**SUBJECT:** AMENDMENT PLAN – 600 Righters Ferry Road, The Royal Athena, Bala Cynwyd, LD# 3683A, Ward 9. *Christopher Leswing*

The applicant, Kevin Kyle, of Righters Ferry Associates, LP (RFA), is seeking **Amendment Plan** approval to reconfigure the approved public gathering space and plaza areas and the removal of nine (9) parking spaces.

Proposed Area

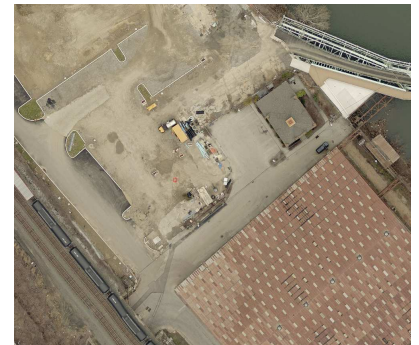
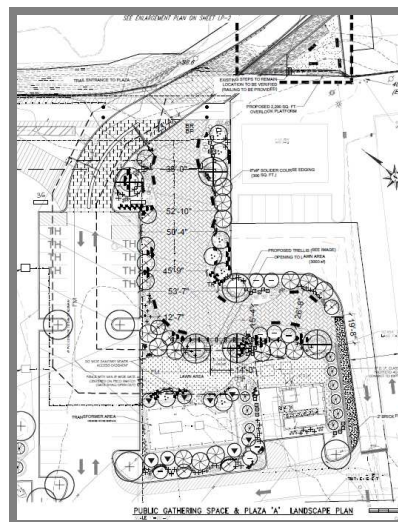
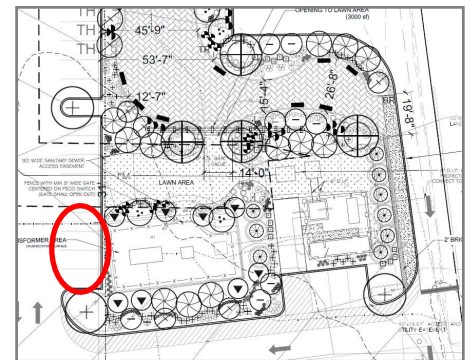
The size and quality of the public gathering spaces have been impacted by the installation of the PECO transformers. Staff has worked with the applicant to redesign the public space to minimize the visual effect that both the elevated transformers and the pump house have on the space, with the goal of creating an attractive space for residents and users of the trail to gather and engage in recreational activities. The public gathering space has been extended to include an area that is cantilevered over the river and which connects to the Pencoyd bridge. Staff observed that the applicant recently installed a significant amount of chain-link fencing in this area and notes that a condition of approval required the removal of all chain-link fencing from the site. Therefore, staff recommends that the chain-link fencing in this area be removed as well.

In an effort to reduce the visual impact of the utilities on the space and create a direct pedestrian connection to and through the space, the applicant has reoriented the space from a linear to a more curvilinear design. The applicant has also included screening elements around the transformers such as a fencing and a trellis. Staff recommends four parking spaces located along the internal access driveway be removed to allow for additional landscape screening along the western side of the transformers.

An important element of the location of the public gathering space is that it connects significant elements on the site including the public pedestrian access to the bridge and the public trail. The redesign provides an improved bike and pedestrian connection from the Pencoyd Bridge to Righters Ferry Road and an existing gate leading to West Laurel Hill Cemetery, which connects to the Cynwyd Heritage Trail. Staff would like to ensure that the pedestrian connections to this space are provided. Staff has included a condition requiring the applicant to continue to work with staff to provide the appropriate connections, including linking the space with Righters Ferry Road and making the space ADA accessible by adding a ramp from the public trail.

### 2. Plaza Areas

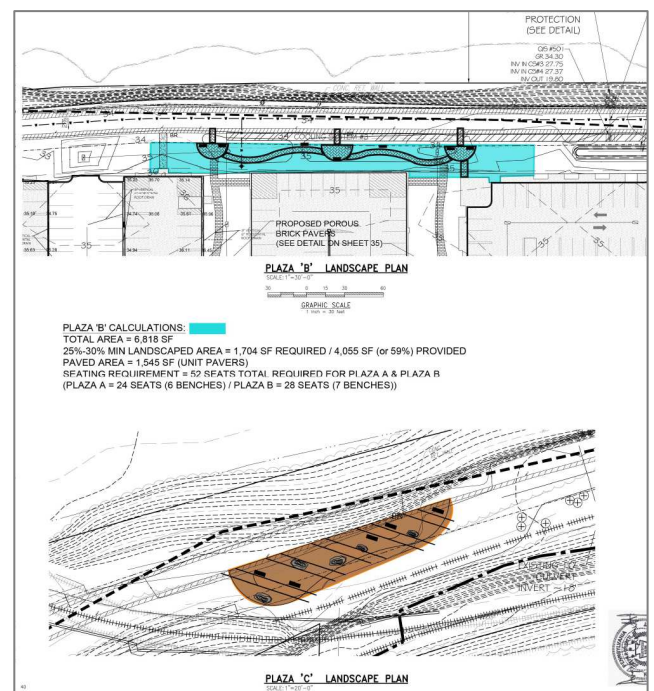
The approved plan showed two Plaza areas (Plaza A & Plaza B) and the proposed plan creates a third plaza area. Plaza A is located adjacent to the public gathering spaces, Plaza B is located adjacent to the trail and new Plaza C is located along the western portion of the property adjacent to the tow path bridge.

Plaza C is located in an underutilized portion of the site and incorporates railroad ties, a nod to the property's historical railroad connection which also meets a condition of approval requiring the

applicant to incorporate industrial material from the site.
